**SUNDRY NOTICES AND REPORTS ON WELLS**

| 4. Location of Well (Footage, Sec., T. R. M. or Survey Description)<br><b>1940' FSL &amp; 1320' FWL, Sec. 1, T27N, R8W</b><br><b>1940' FSL &amp; 1320' FWL, Sec. 1, T27N, R8W</b> | 8. Well Name and No.<br><b>Stove Canyon #1</b>            |

Conoco Inc. proposes to alter the original casing plan that was originally submitted under the APD. Attached you will find the procedure that we are requesting that the BLM approve.

**Stove Canyon #1 — Draft Completion Procedure**  
**REVISION #2 (after 12/4/97 mtg).**

## Wellbore Schematic

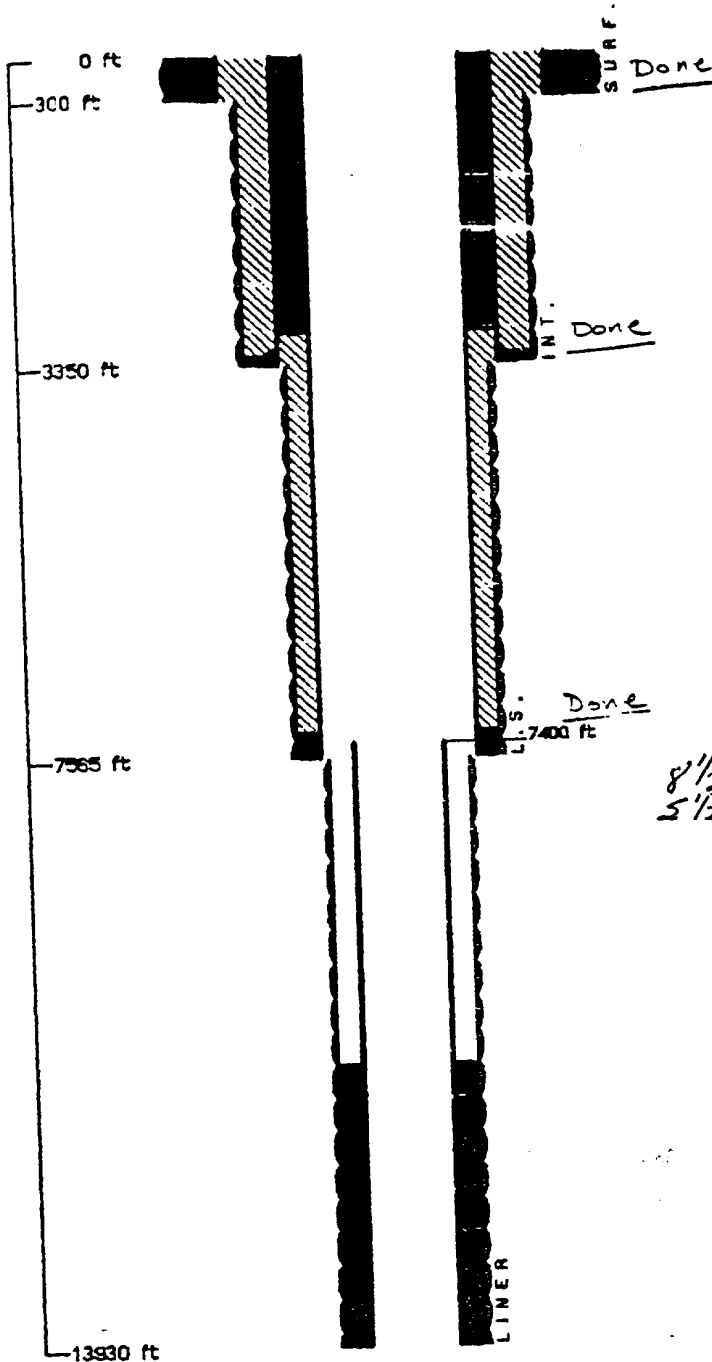
5 1/2", P 110 , 23#, LT&C production casing from surface to TD. 16#, CClass H cement (FL 32 + BA 58 system) from TD up to 11,500' ( 8 1/2" hole ).

NOTE 1 — Conoco/BJ Rationale for running cement only to 11,500':

- a. To SAFELY cement the entire casing string to shoe, without creating excessive ECD to cause breakdown of Penn formation during cementing, staging of the cement job would be necessary (ie, installing stage tool in csg). Due to necessity of high pressure acid frac stimulation down casing for the completions, coupled with inherent risks of stage tool seal leaking, staging not recommended.

- b. By only doing single stage cement job (rotating pipe to ensure good bond, etc) over the entire Penn interval, a good, safe & low damaging (ie, for fractured formation) cement job can be assured over test interval. In addition, if Penn test unsuccessful, cost savings will be realized in not pumping upper stage cement slurry, coupled with better pipe recovery. By getting better pipe recovery, a more effective P&A procedure can also be achieved.

- c. IF zones above 11,500' are identified as test candidates, or the Penn tests prove successful, the upper section of the 5 1/2" (from 11,500' to the shoe) will be cemented, by installing a plug @ TOC, shooting squeeze holes just above, and circulating.
